MIAMI-DADE COUNTY
DEPARTMENT OF TRANSPORTATION AND PUBLIC WORKS (DTPW)

ADDENDUM NO. 2
September 22, 2022

PROJECT: Roadway Improvements to NE 151 Street from East of Railroad Tracks to Bay Vista Boulevard.
Project No. 20210092

Re: NE 151 Street Revision 2 Memo

Revised Sheets for Addendum No. 2

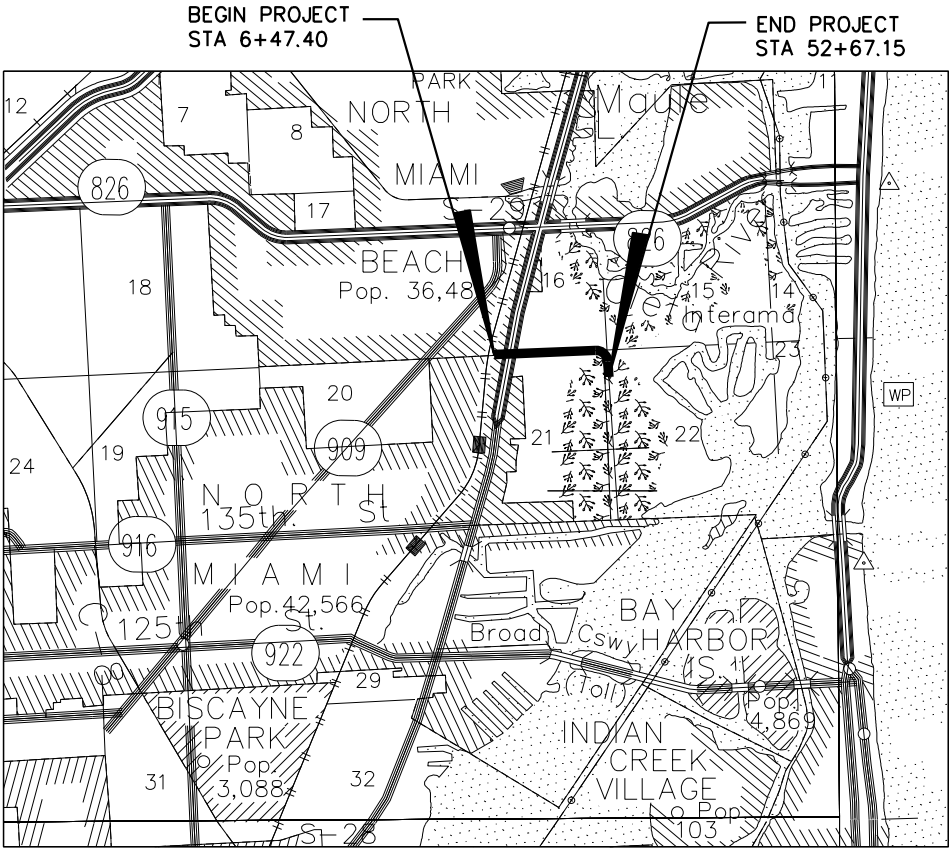
| Sheet Number | Revision Date | Description |
|--------------|---------------|---|
| 1 | 9/22/22 | Updated Key Sheet to include Revision No. 2 |

- ROADWAY SHEETS 2, 3 & 5 (9/9/22)
- SIGNING SHEETS 83 & 91 (9/9/22)
- SIGNAL SHEETS 95 & 100 (9/9/22)
- LIGHTING SHEETS 107 & 117 (9/9/22)
- UTILITY SHEETS UTV-1 TO UTV-3 (9/9/22)
- ROADWAY SHEET 5 (9/22/22)
